Lancaster County School District Amendment #1	Solicitation Number	202502	
		Solicitation Issue Date	07/30/24	
		Amendment Issue Date	8/12/24	
		Procurement Officer	Trevor Hammond, NIGP-CPP, CPPB (803) 416-8828	
		E-Mail Address	trevor.hammond@lcsd.k12.sc.us

DESCRIPTION: **Restrooms for BHS & LHS Baseball Fields**

Effective this date, this amendment forms part of the contract documents and modifies the original IFB

6 THRUST BLOCKING - BEND
C601 NTS

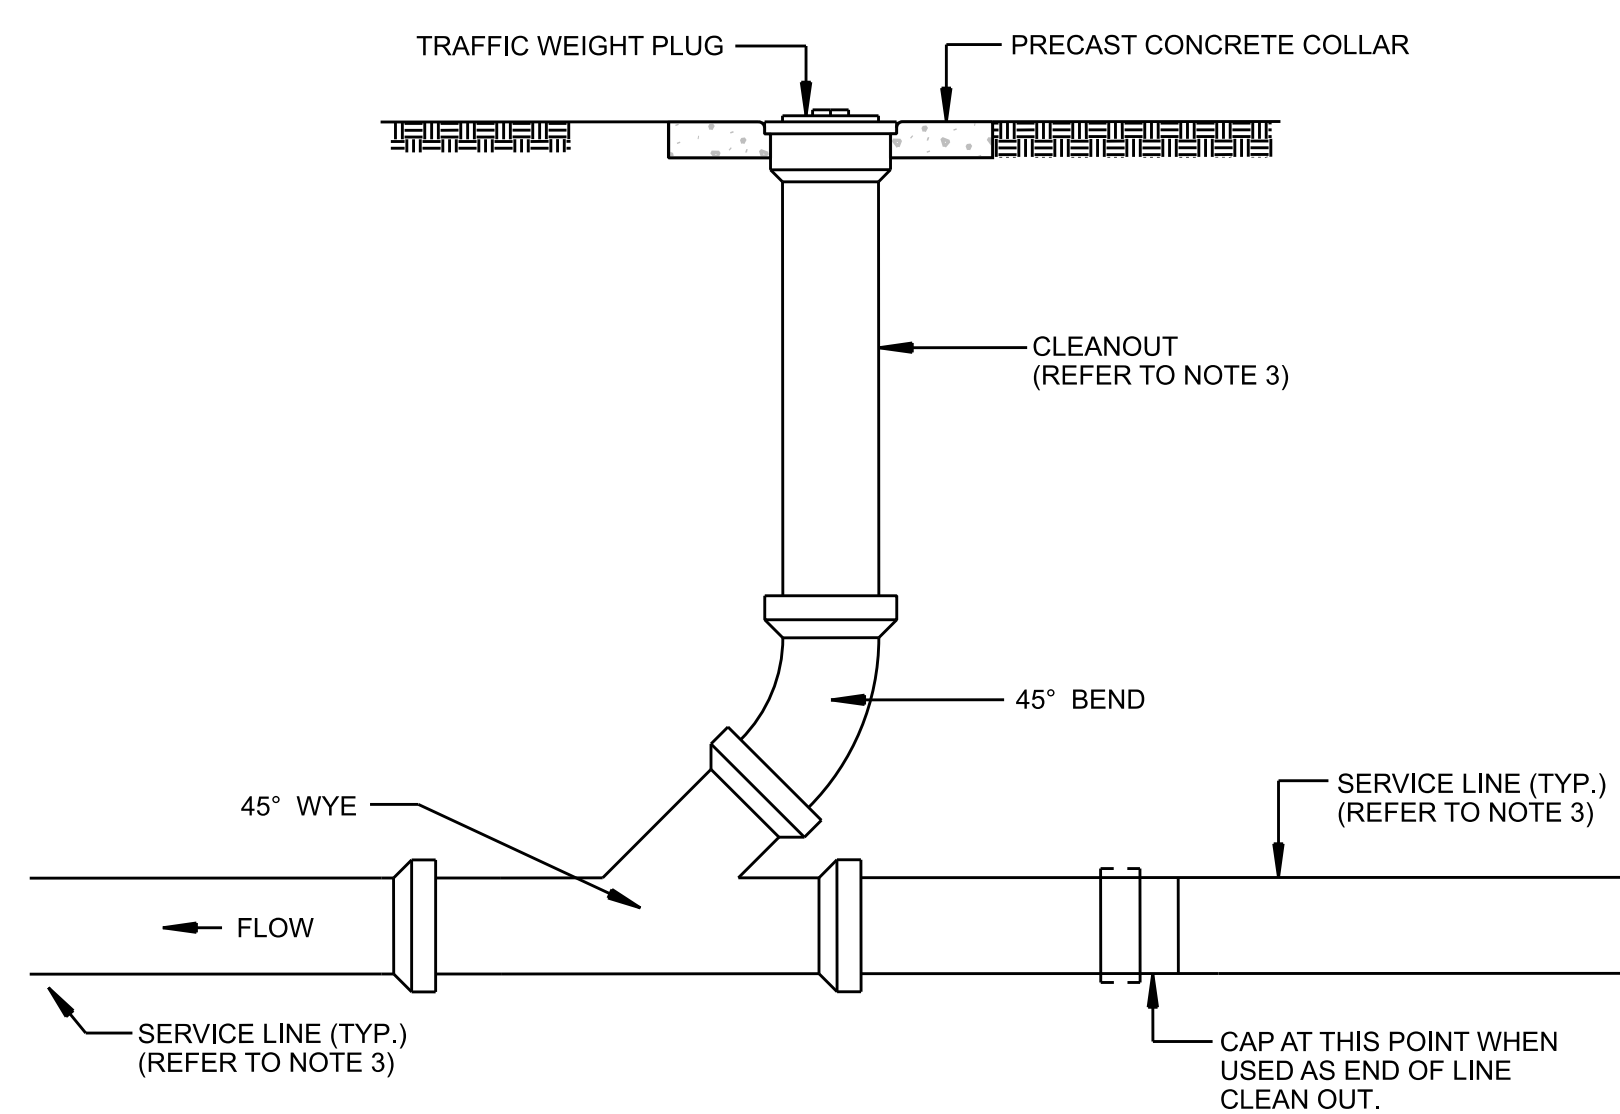
2. 2-inch compression fittings have been revised to 2-inch fittings with blocking.
- D. Replace sheet C601 with revised sheet C601 – Water & Sanitary Sewer Details, included in the Attachments.

1. 2-inch polyethylene C-901 water service line has been revised to a 2-inch PVC SDR-21 water service line.
 2. 2-inch compression fittings have been revised to 2-inch fittings with blocking.

C1 FRONT ELEVATION
1/4" = 1'-0"

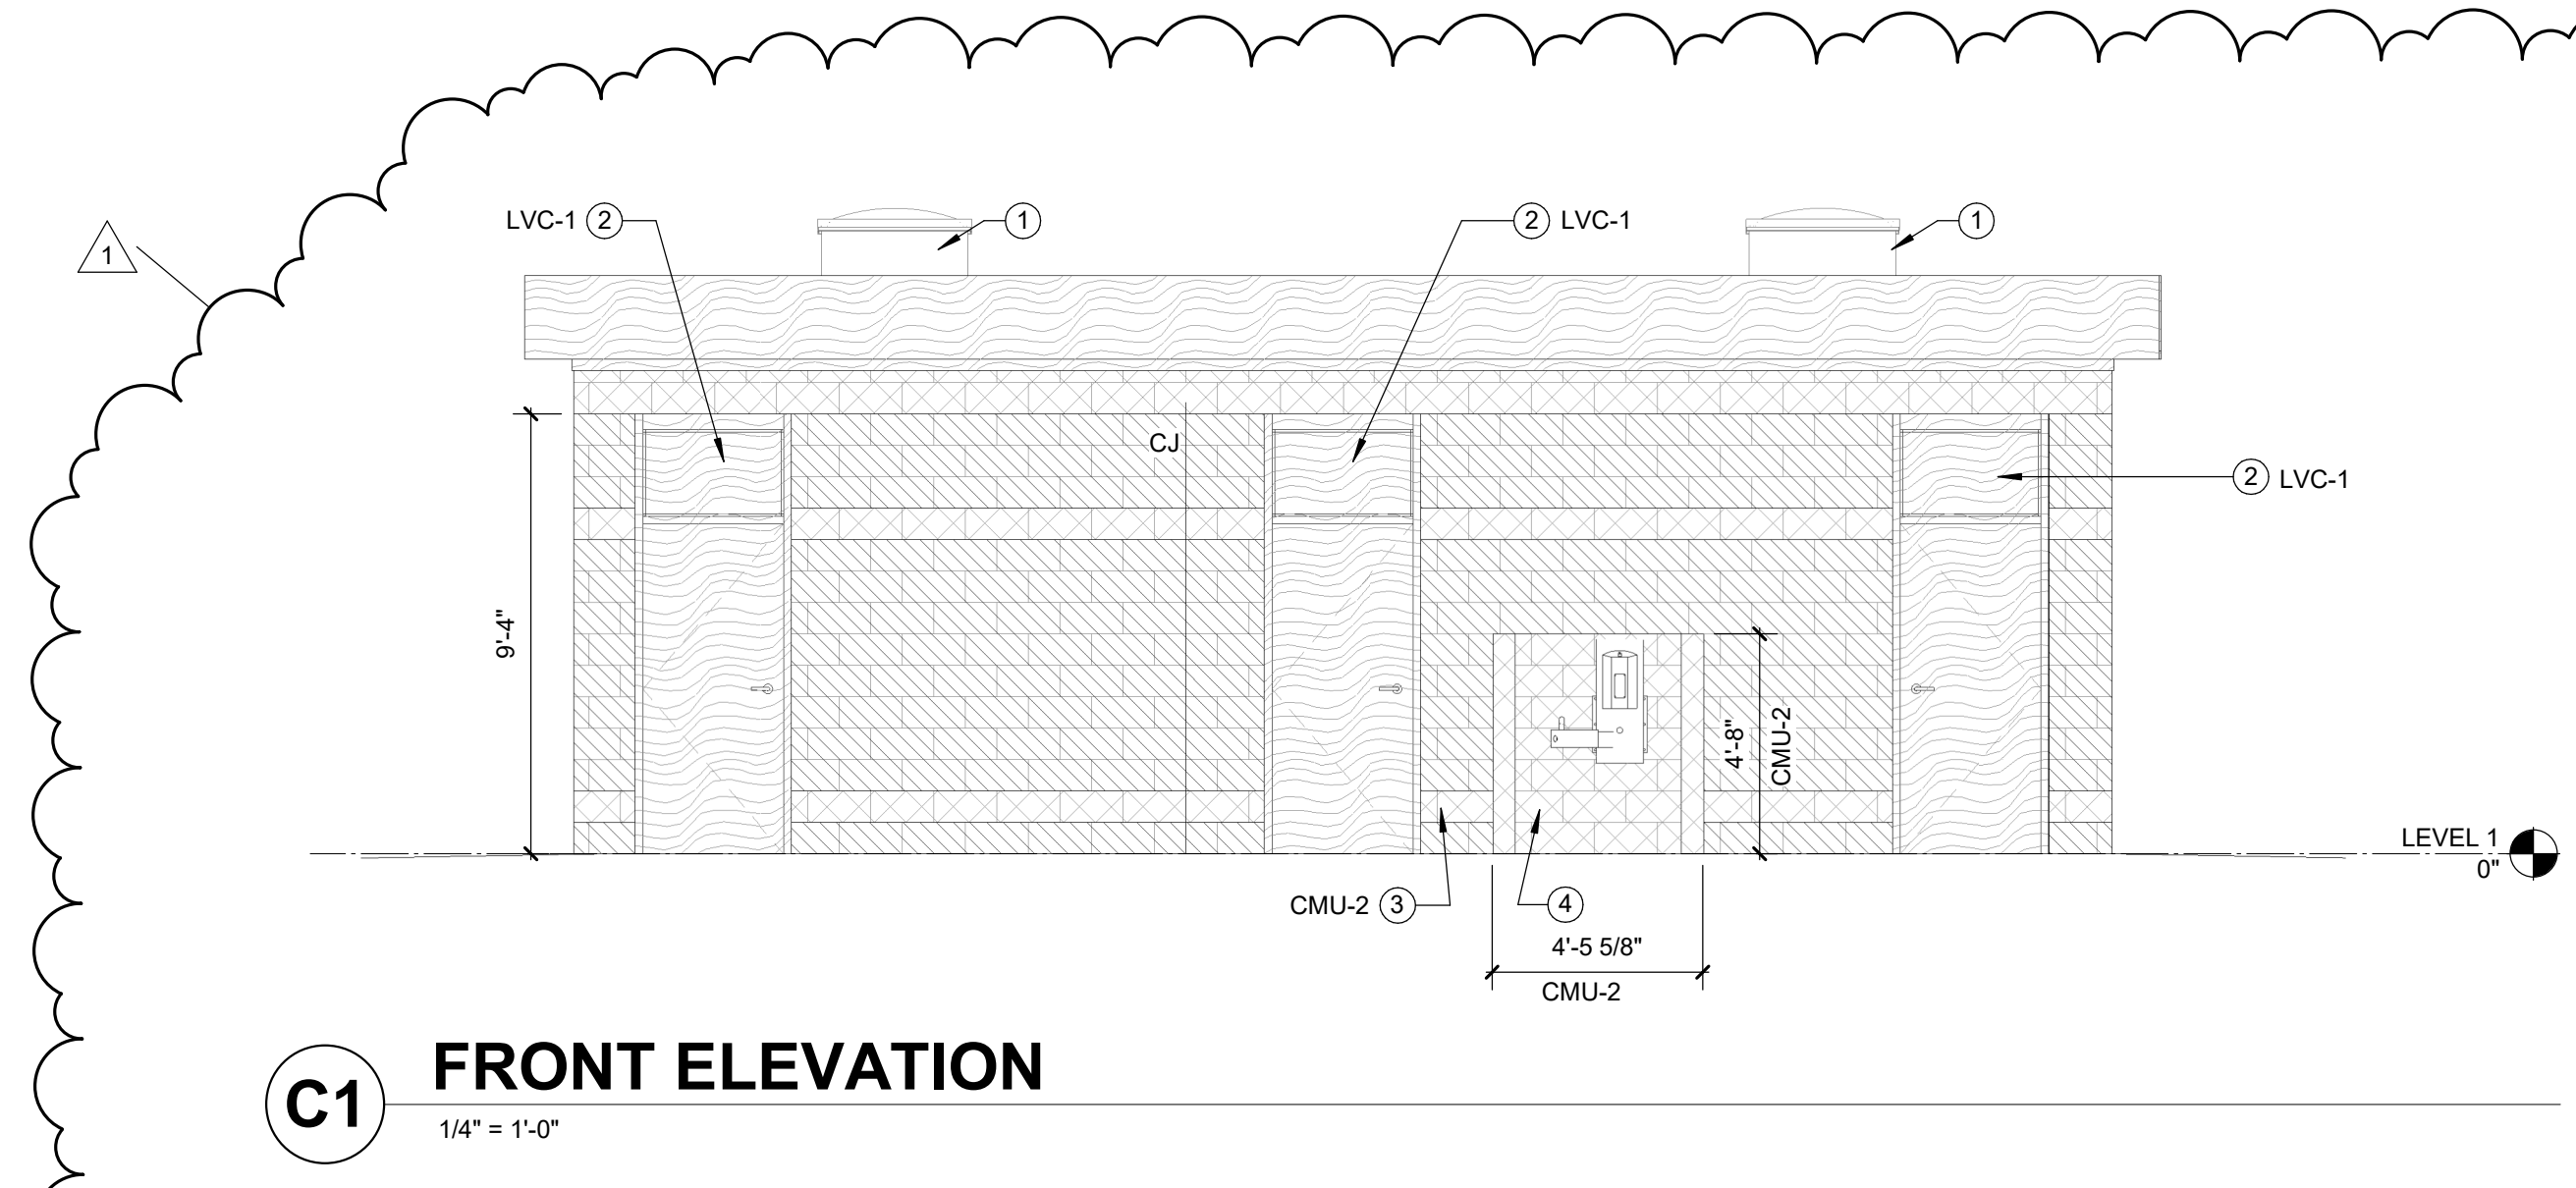
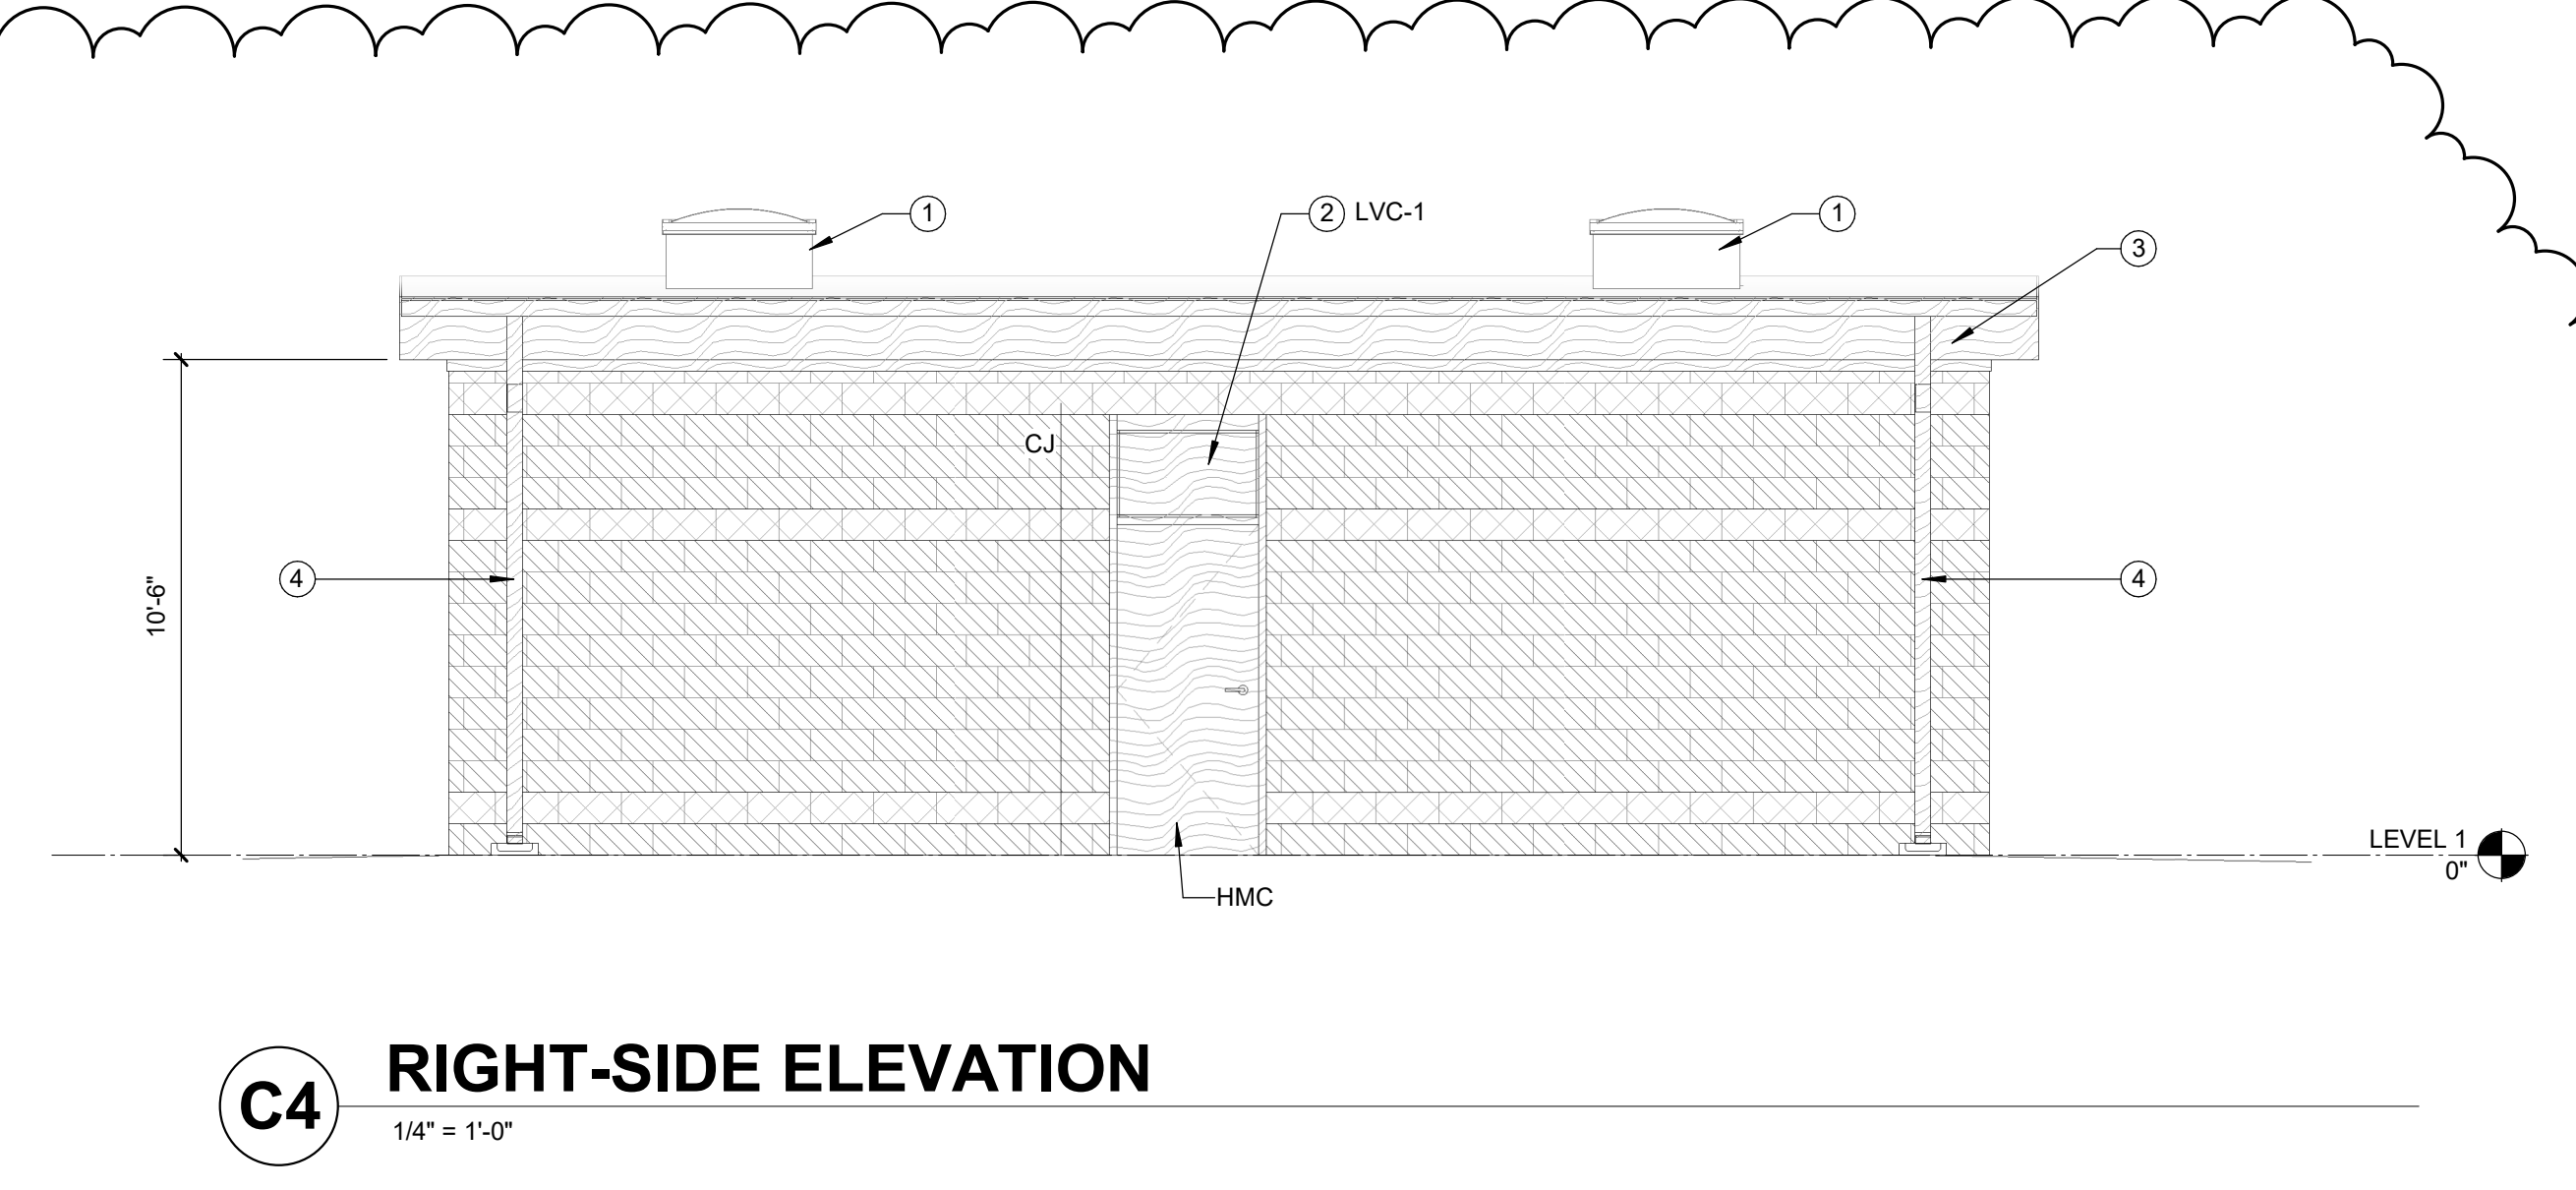
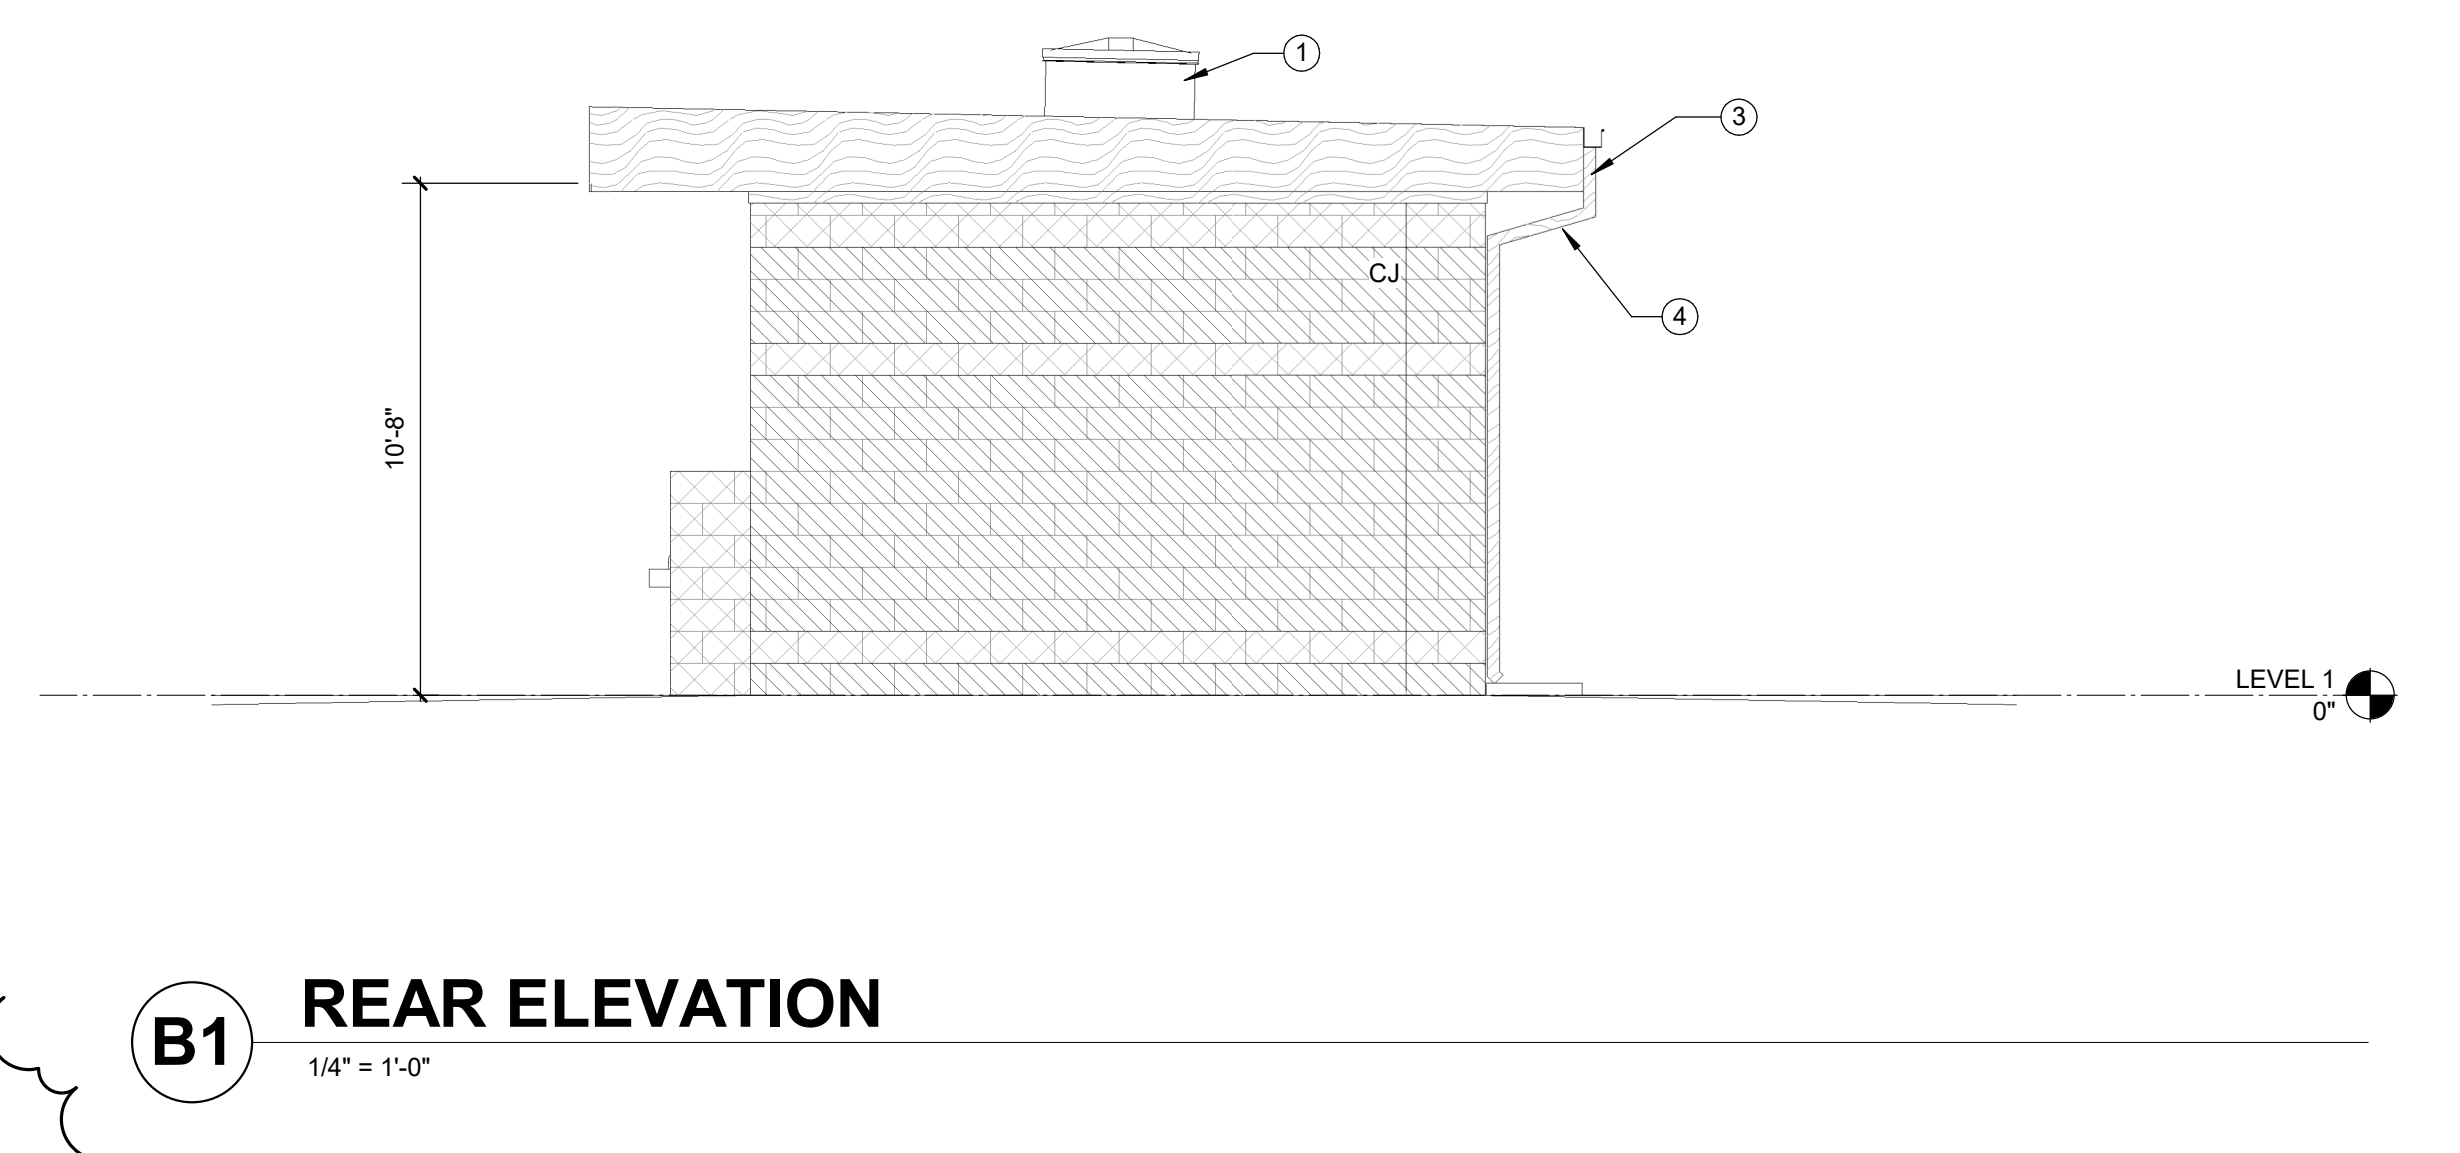
- F. Replace Sheet A-201 with revised sheet A-201 – Exterior Elevations, included in the Attachments.
 - 1. Elevations, legend and schedule were revised to remove exterior block that was to be painted in lieu of colored smooth and split face CMU.
